E5071B-12C

S E R V I C E N O T E

E5071B RF Network Analyzer, 300kHz to 8.5 GHz

When E5071B has the old step attenuator (33321-60059) and fails Internal Test at Step Attenuator Test Group, replace the old attenuator (33321-60059) by improved version (33321-60068), add additional cable and update firmware to 5.02 or later

Figure 1 Make A7 assembly (for option 213 and for option314/414 with 1 attenuator)

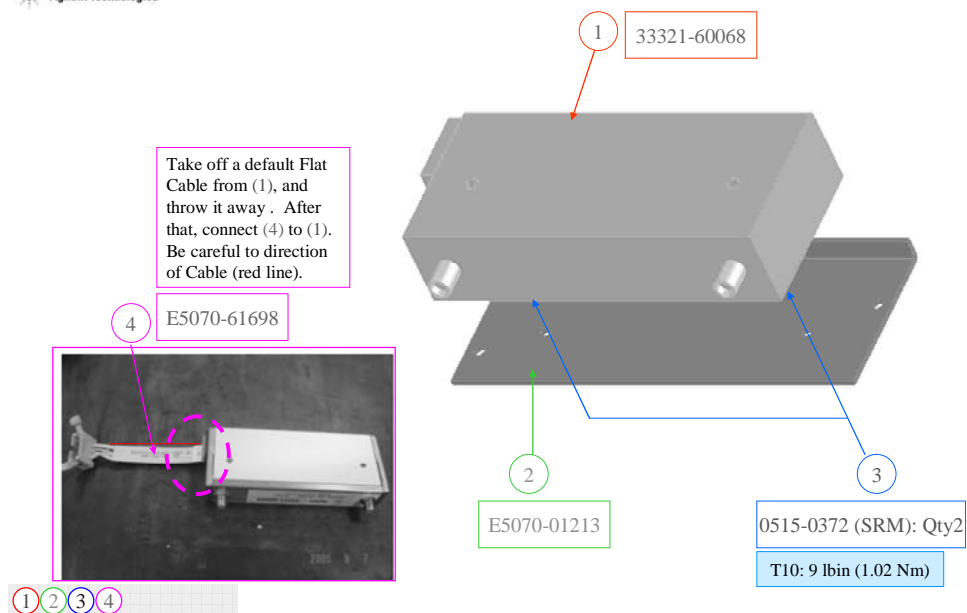
1. Disassemble the product. (Refer to E5070B/E5071B Service manual chapter 6 for details)
2. Make A7 step attenuator assembly by 33321-60068 (1ea), E5070-61698 (1ea), E5070-01213 (1ea), 0515-0372 (2ea) and E5070-61617 (1ea). E5070-61698 is the cable between 33321-60068 and E5070-61617. Scrap 33321-60059.
- 2-1. Scrap the flat cable that comes with the new attenuator (33321-60068).
- 2-2. Connect E5070-61698 to 33321-60068.
- 2-3. Connect E5070-61698 to E5070-61617.

Figure 2 Install A7 attenuator assembly (1)

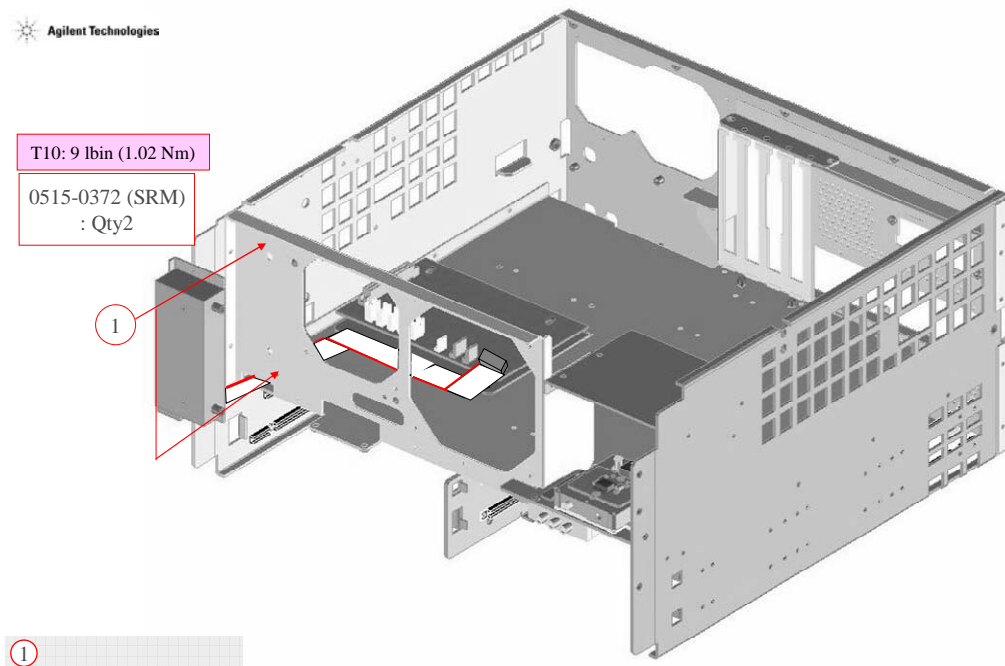
3. Install A7 assembly with 0515-0372 (2ea).

Figure 3 Install A7 attenuator assembly (2)

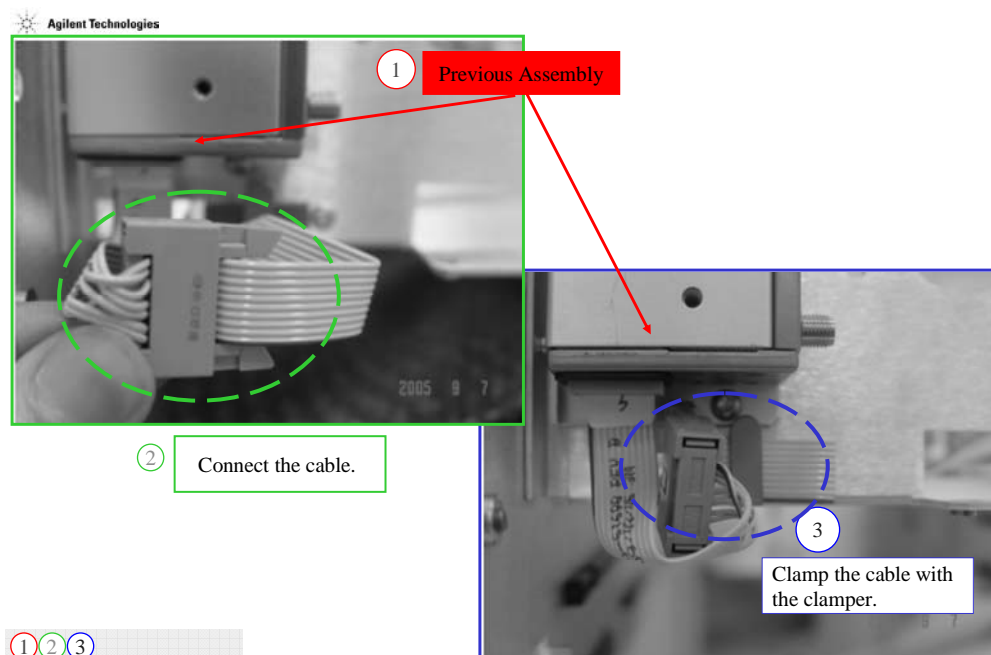
4. Connect the cable and clamp the cable with the clamer. Be careful to flat cable direction and its connectivity.

Figure 4 Make A7 assembly (for option 314/414 with 2 attenuators)

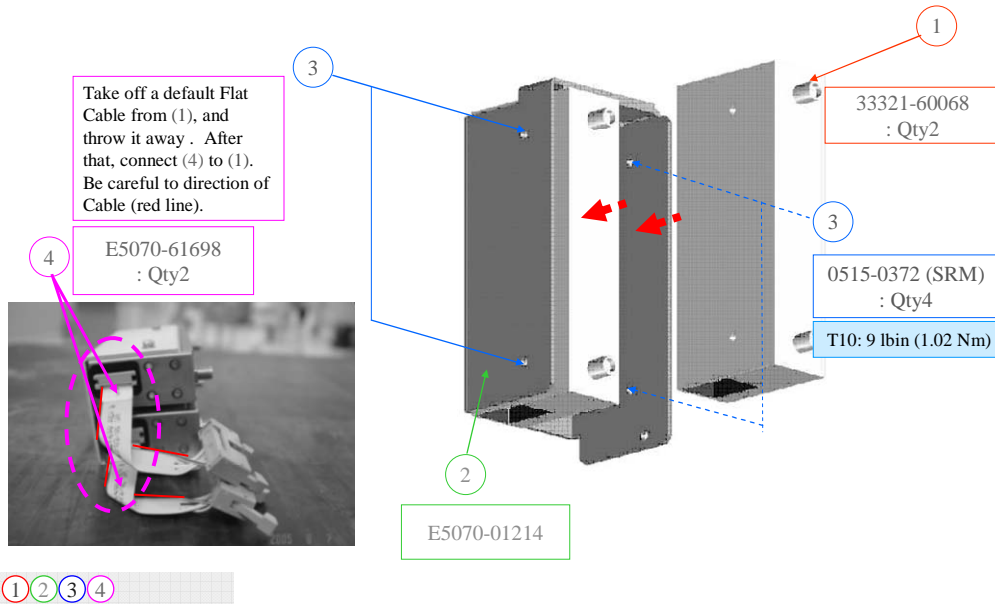
1. Disassemble the product. (Refer to E5070B/E5071B Service manual chapter 6 for details)
2. Make A7 step attenuator assembly by 33321-60068 (2ea), E5070-61698 (2ea), E5070-01214 (1ea), 0515-0372 (4ea) and E5070-61618 (1ea). 2ea of E5070-61698 are the cable between 33321-60068 and E5070-61618. Scrap 33321-60059.
- 2-1. Scrap the flat cable that comes with the new attenuator (33321-60068).
- 2-2. Connect E5070-61698 to 33321-60068. (This is done twice)
- 2-3. Connect E5070-61698 to E5070-61618.

**Figure 5** Install A7 attenuator assembly (1)

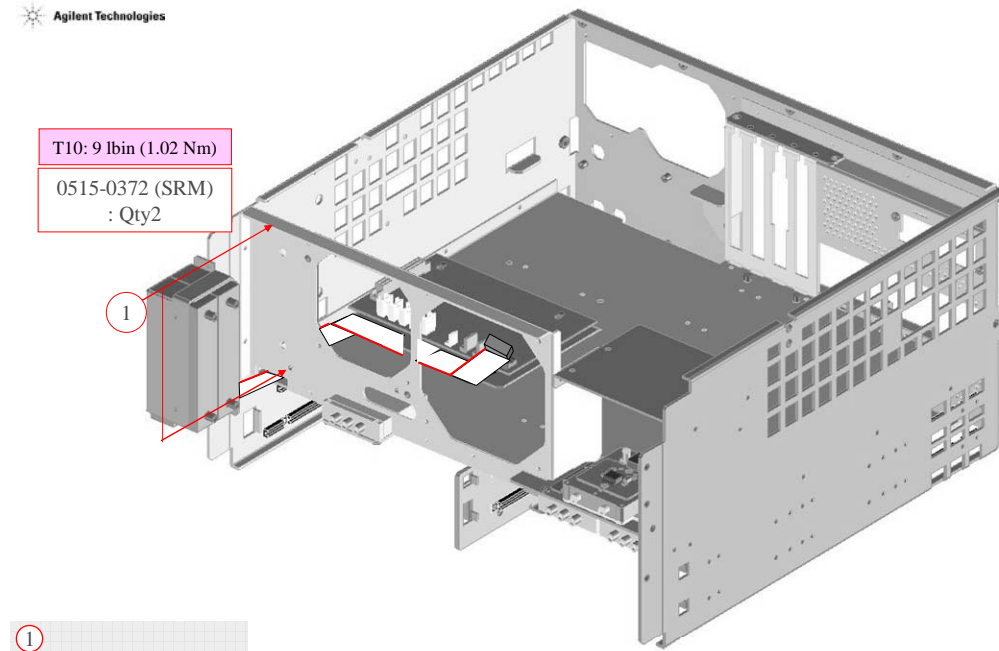
3. Install A7 assembly with 0515-0372 (2ea).

**Figure 6** Install A7 attenuator assembly (2)

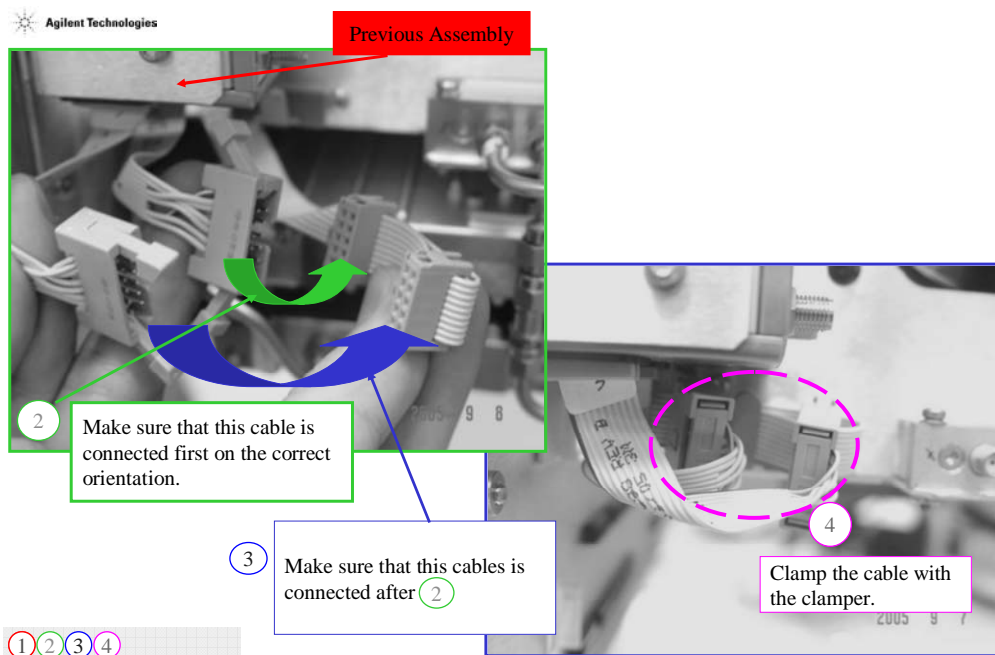
4. Connect the cable and clamp the cable with the clammer. Be careful to flat cable direction and its connectivity.
